HILLS SHOWGROUND STATION PRECINCT - PRECINCT EAST 3 ANDALUSIAN WAY - LOT 3 & 4

State Significant Design Excellence Report

The Design Excellence Report is to provide an overview of the second State Design Review Panel (SDRP) held on 5th June 2024 and provide a response to the matters raised by the members.

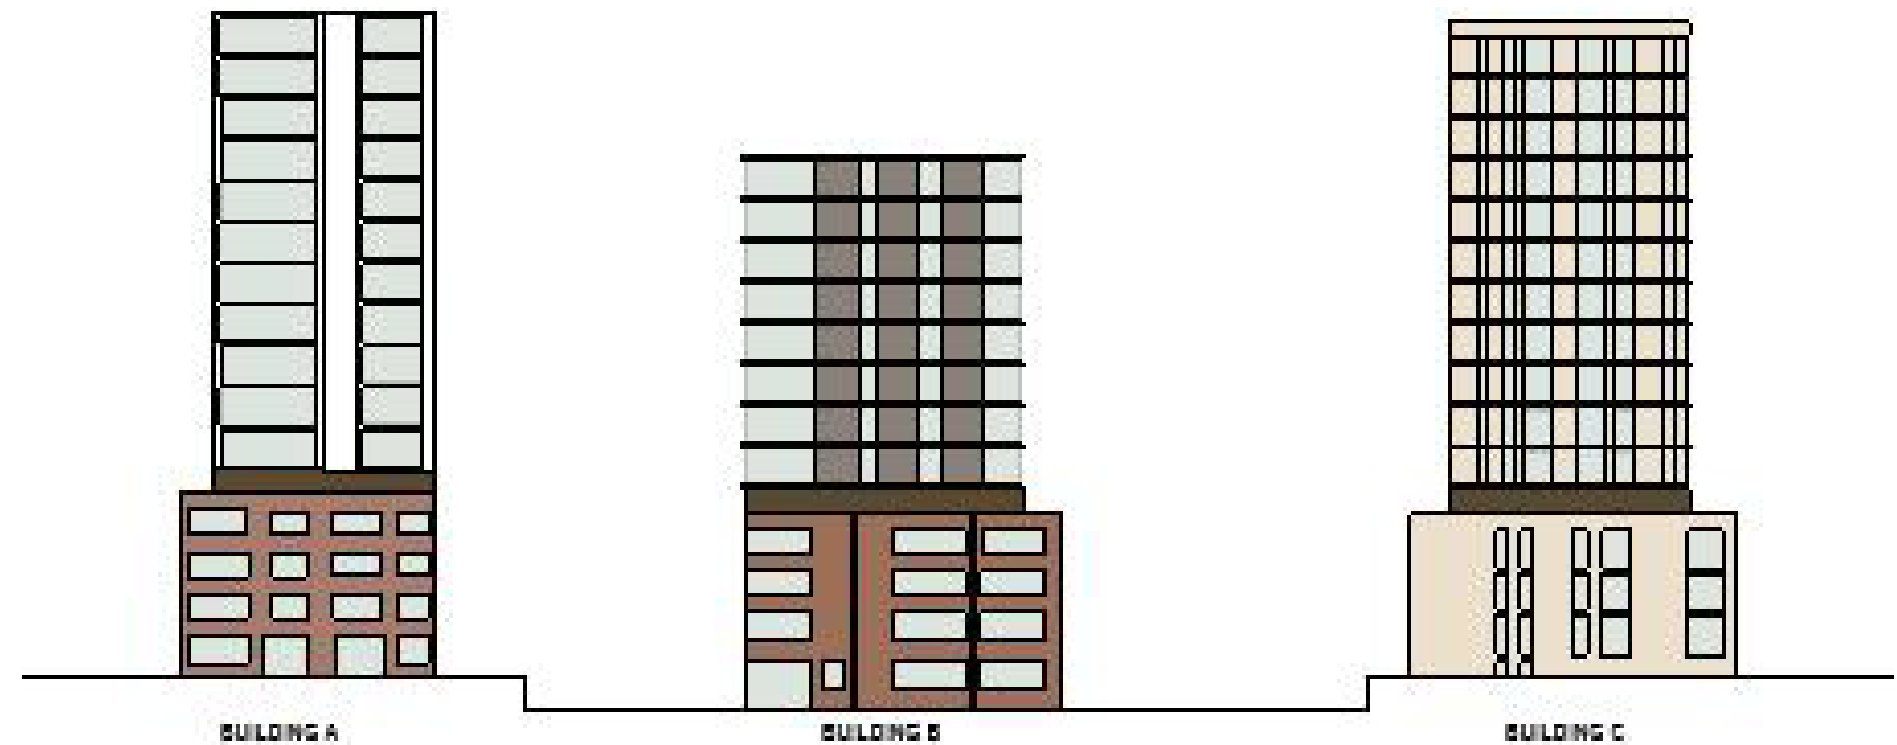
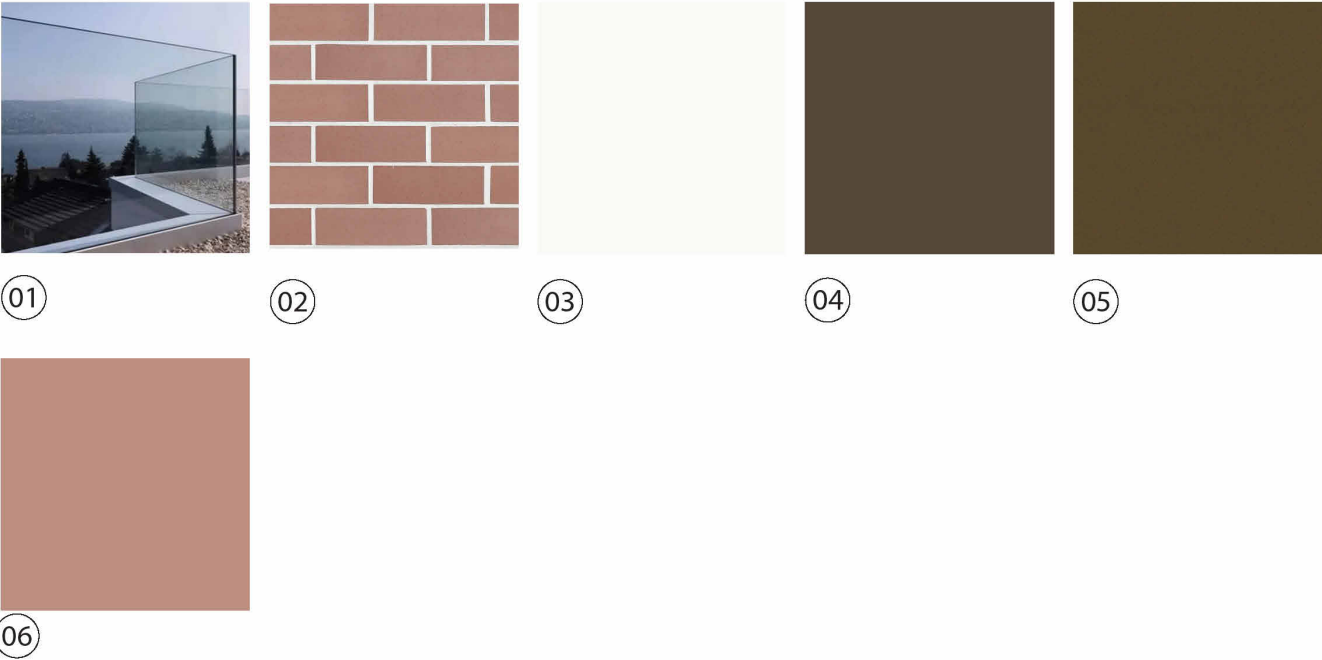
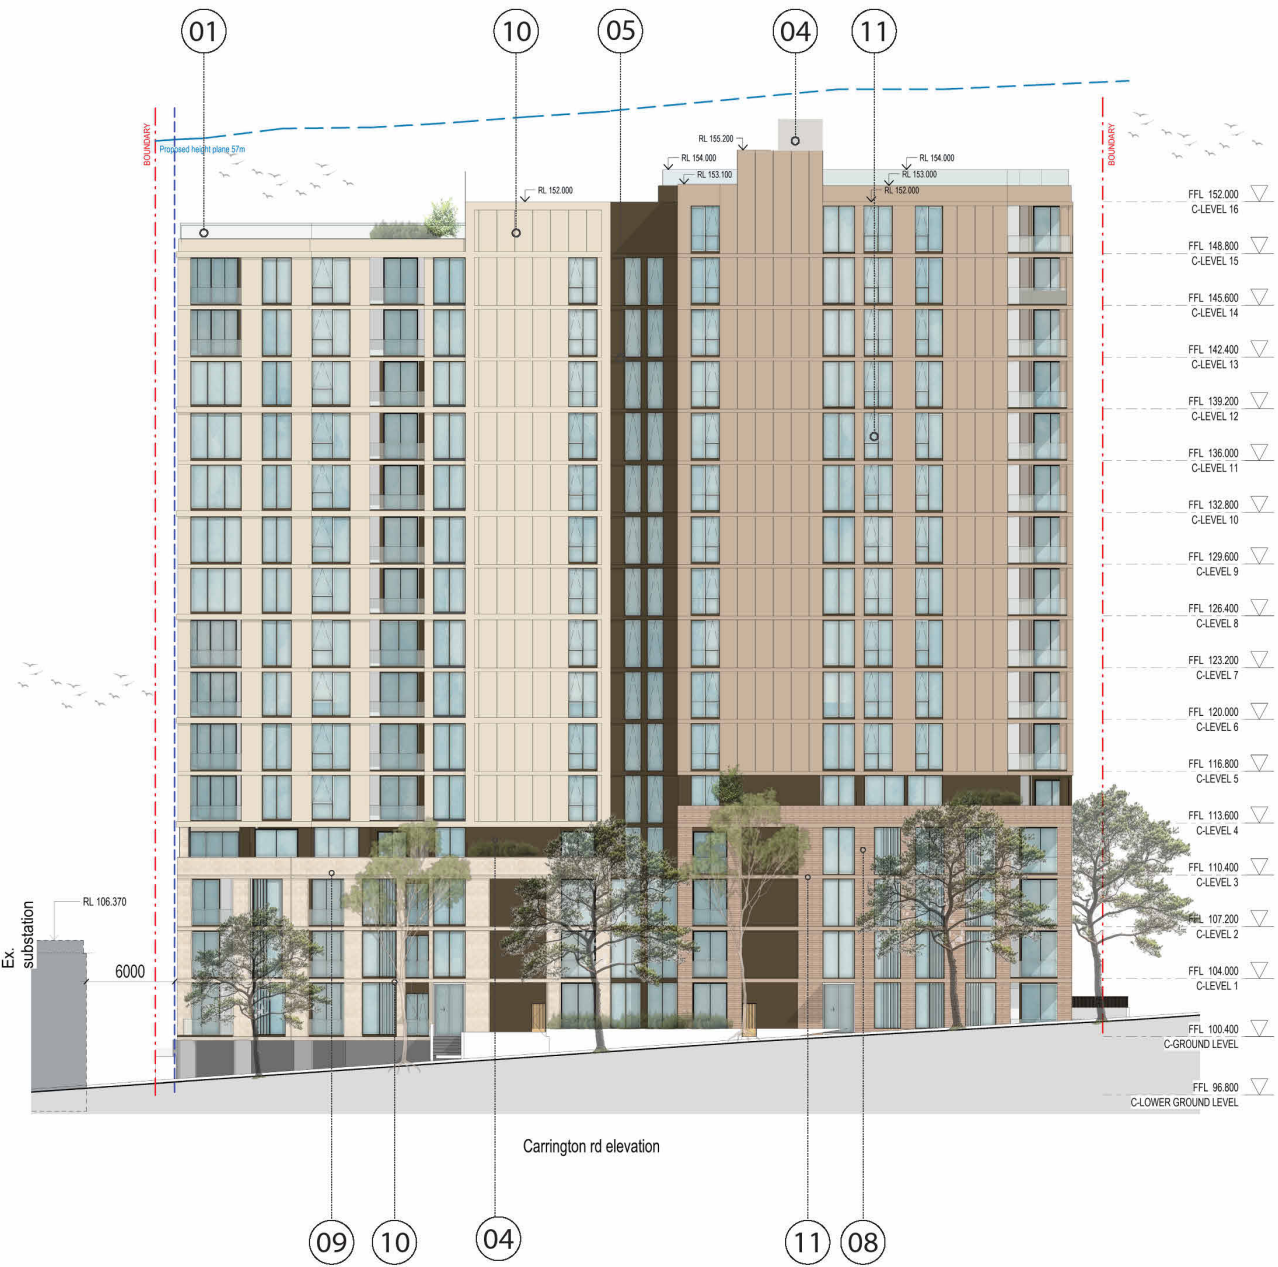
SDRP 1 - Comment 10

"The use of different architectural teams to ensure diversity is supported. However, given the scale and complexity of the proposal, it is important that clarity and vision is maintained."

GSA have approached a site wide strategy taking inspiration from the adjacent Doran Drive precinct, Castle hill train station and Castle Hill Showgrounds and using materials and architectural form in keeping with both the contemporary and local brick vernacular.

The podium of Building A in Lot 4 features a solid, sculpted brick base, defined by a strong vertical colonnade that visually connects with the tower rising above.

The tower is articulated through horizontal slab bands overlaid with a modular vertical framing system, creating a balanced expression of structure and rhythm.

The angular splay at the balcony edges of Building A is retained at the tower level as a defining feature, framing the building and reinforcing its presence within the Showground precinct, where it responds to the openness of the surrounding area.

At the podium level, Building B is composed of a range of warm toned brickwork, detailed with a strong vertical colonnade that reflects and responds to the local architectural vernacular of Castle Hill.

The solid, grounded podium contrasts with the lighter expression of the tower above, where exposed horizontal slab edges and metal-framed glazing introduce a more refined and lightweight character to the built form of Lots 3 and 4.

This approach helps mediate between the adjacent massing of Buildings A and C.

Similarly, the podium of Building C in Lot 3 adopts a brick material palette consistent with Buildings A and B, establishing a cohesive and repetitive architectural language across the development. The tower is divided into two complementary colour palettes, enhancing its verticality and drawing inspiration from the strong vertical grid patterns of the nearby Metro Station and substation.

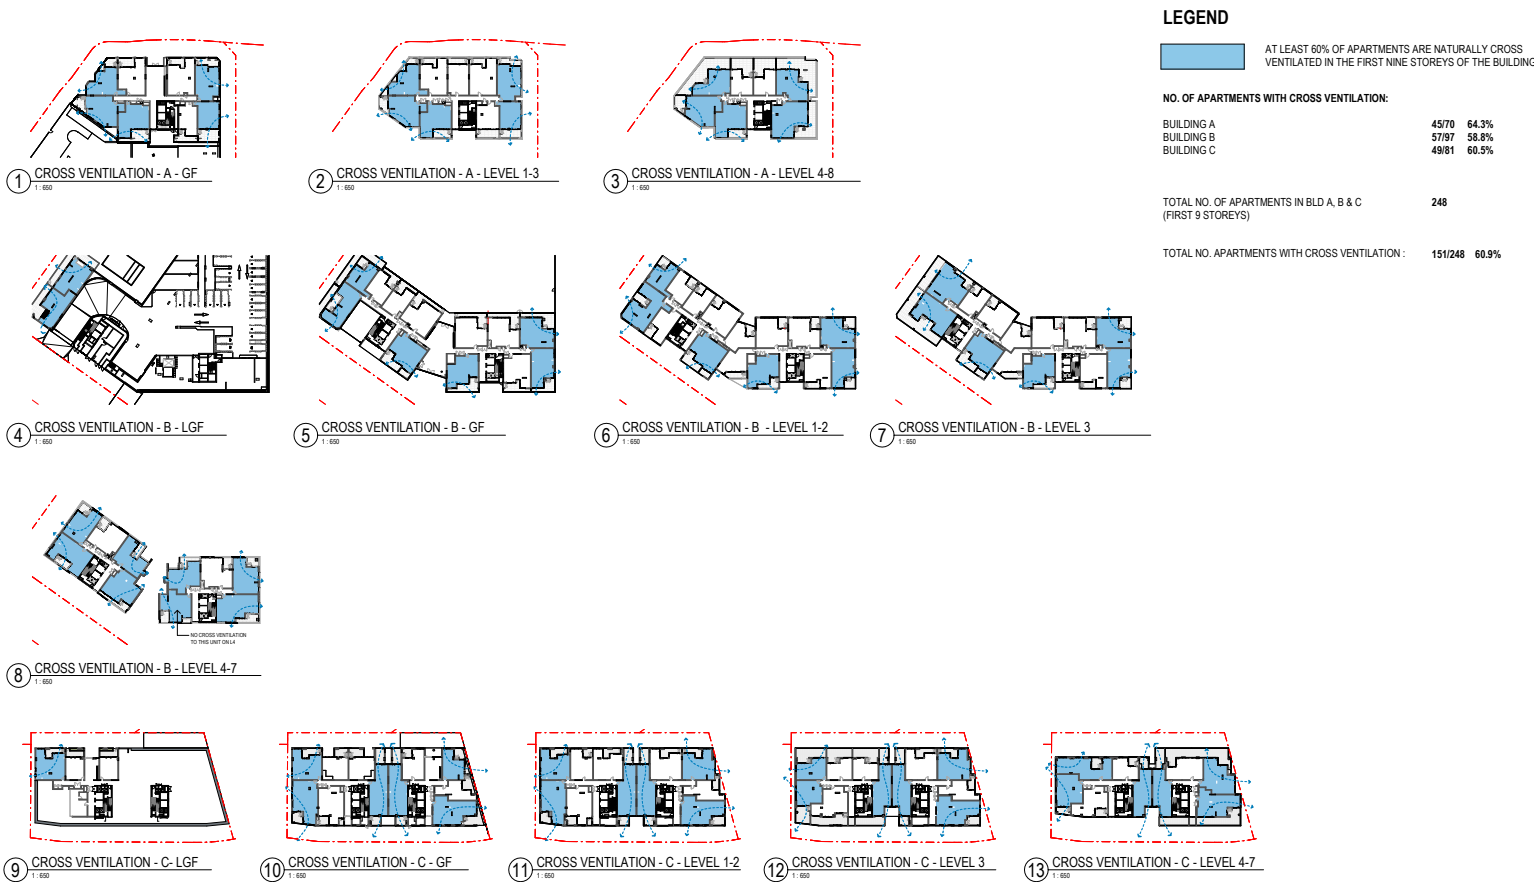
SDRP 1 - Comment 11

"Demonstrate that apartments noted as having cross ventilation are genuinely dual aspect. Layouts may need to be reconfigured to achieve ADG compliance."

62% (154) Apartments achieve natural cross ventilation.

To achieve the required natural cross ventilation in Lots 3 & 4, the concept plan massing of Building B tower is sub divided it Tower B1 & B2. This approach reduces the bulk and scale of Building B’s massing while enhancing the cross ventilation in corner units.

As noted at the first SDRP review, the proposed design replaces through 3B units located on L1-3 in Building B. The reconfigured design enables

stacked unit types in the tower & podium, with smaller one bed units located on L1-3 providing improved structural rationalisation while maintaining ventilation requirements. improved structural rationalisation while maintaining ventilation requirements.

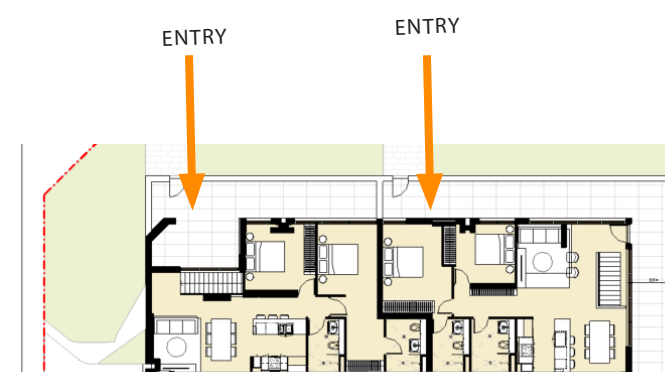
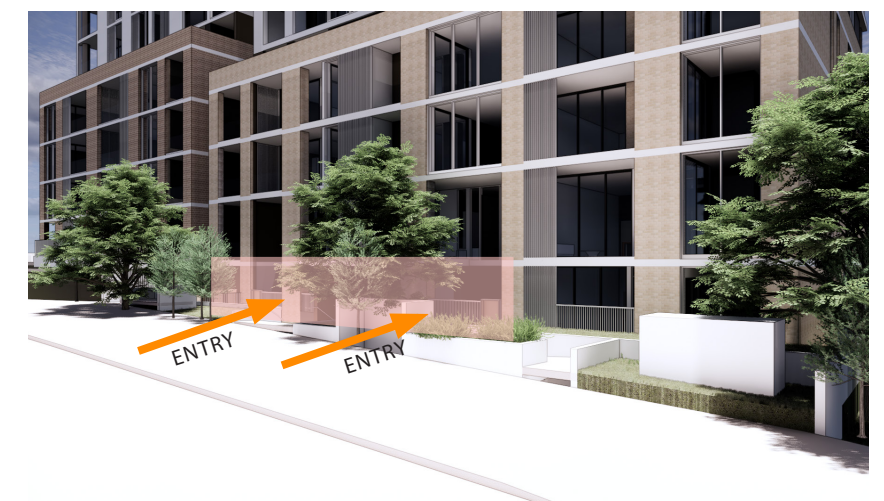
SDRP 1 - Comment 13

"The terrace house typology and further diversity in general is supported. a. Extended the terrace house typology to Lots 3 and 4, rather than solely Lot 5. b. Explore larger cut outs from the terrace house massing to increase the size of the balconies at the first floor."

Group GSA have provided Townhouse style unit to lower ground floor apartments on both Building B & C with access from the street and an architectural expression that varies from the Podiums levels above. Direct access to the courtyard has been provided on Ground floor units facing the courtyard with increased terrace area. This adds to the diversity of the site.

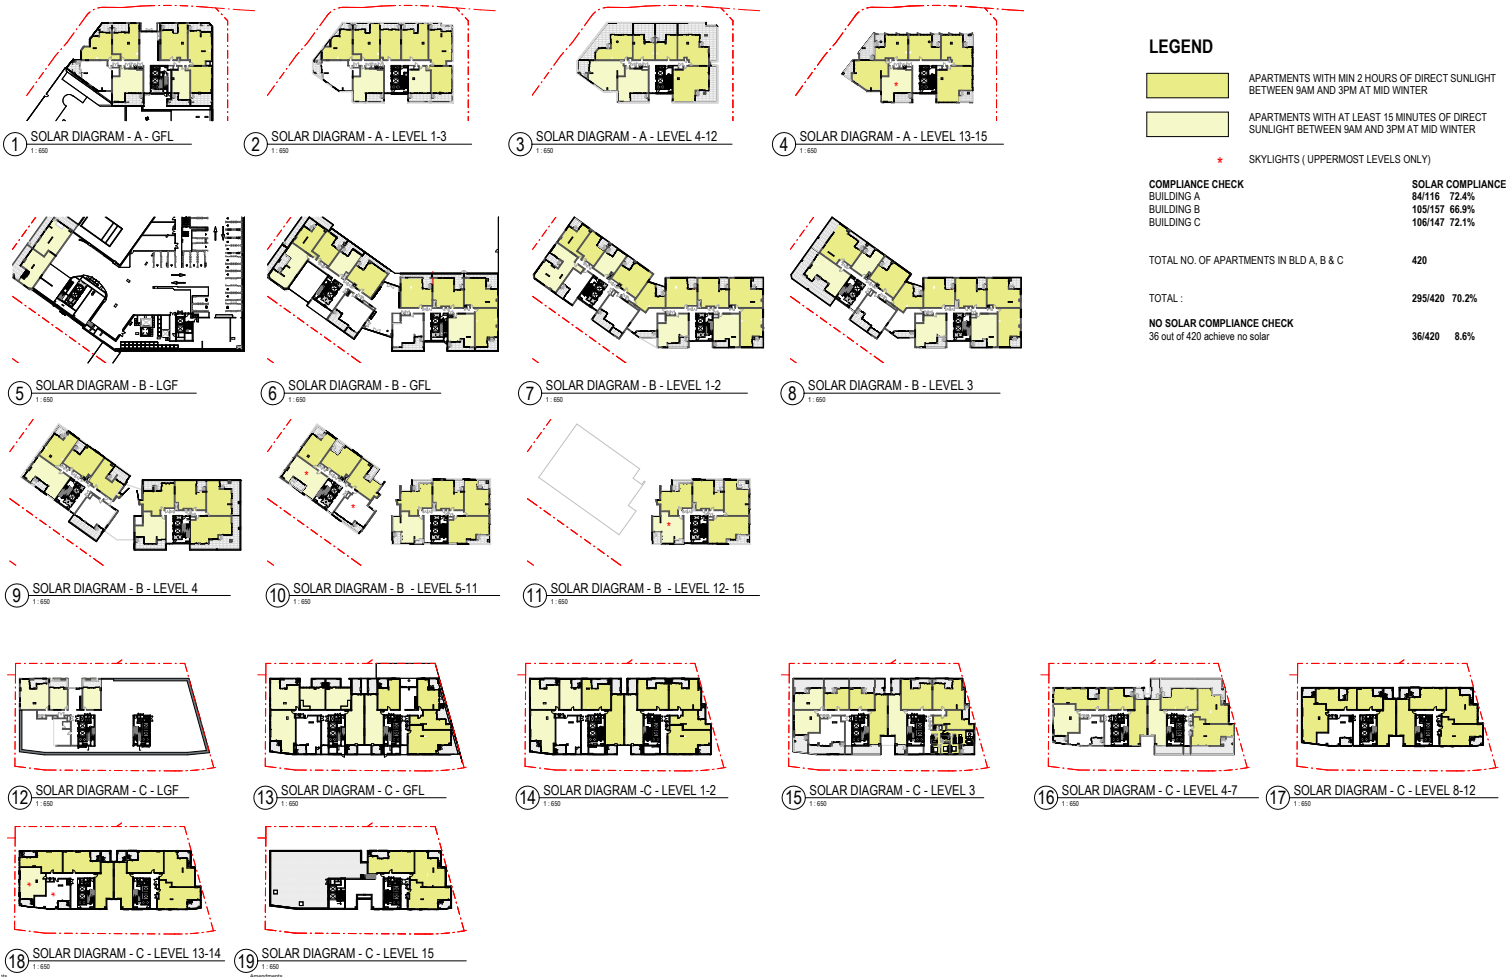
SDRP 1 - Comment 15

"Allow increased tolerance for the rationalisation of architectural massing within the approved envelopes. Simplify the angular massing of buildings at Lot 4, strengthening the north-west corner and reducing balcony types, specifically avoiding smaller triangular balconies. Ensure that private balconies are generous and receive sufficient solar access."

Rationalisation of the architectural massing is improved in Building B, stacking of the apartment either side of the central void between B1 & B2 Tower improves constructability and structural integrity.

Generous balconies designed along Building A west elevation (Upper levels, although still triangular in nature due to existing site massing. All balconies are ADG compliant with greater than 70% units achieving more than 2 hours daylight to Living areas.
